Asrotex (Extension)

08th October 2023

Inconsistencies in design report

Figure 3.7-14: Live load on 1st Floor (unit=lb/sft)

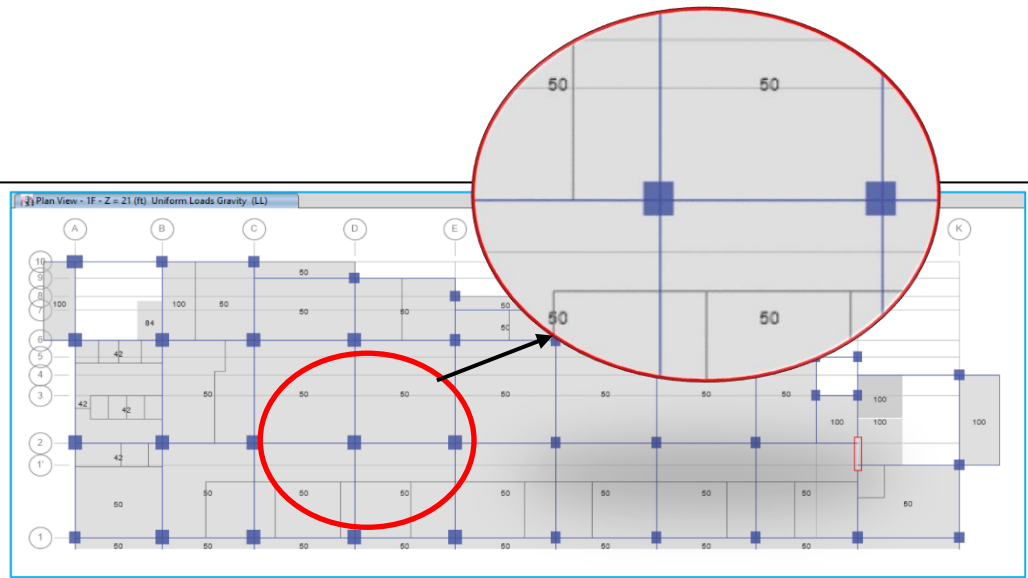
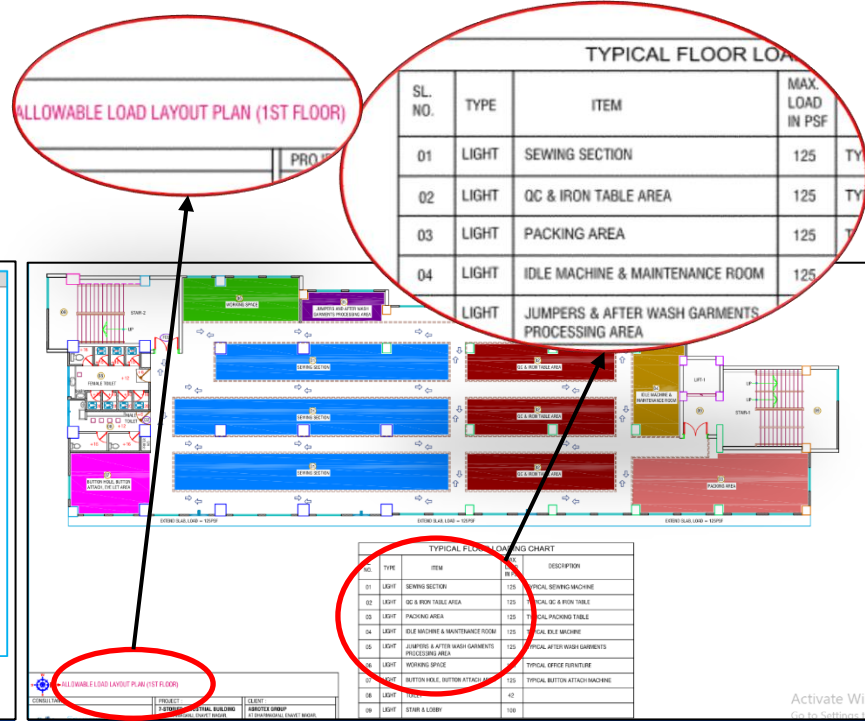
Software based analysis: 50psf (2.5 kPa) live load

Load plan: 125psf (6 kPa) live load on 1st

In design and analysis, first floor live load was considered as 50psf. Hence, in the posted load plan 125psf has been considered beyond the design & analysis. Building engineer is required to check the floor load plan, update as per NBC requirement and revise the design documents accordingly.

Exposed reinforcement left at each level

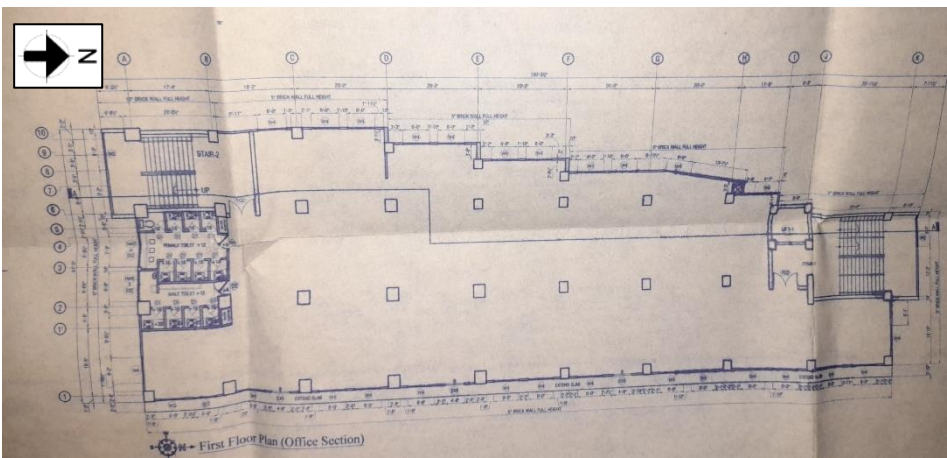
Exposed reinforcements had been left at each floor level staircase which were prone to corrosion. Factory is required to provide rust proof paint on exposed reinforcement to protect from corrosion.
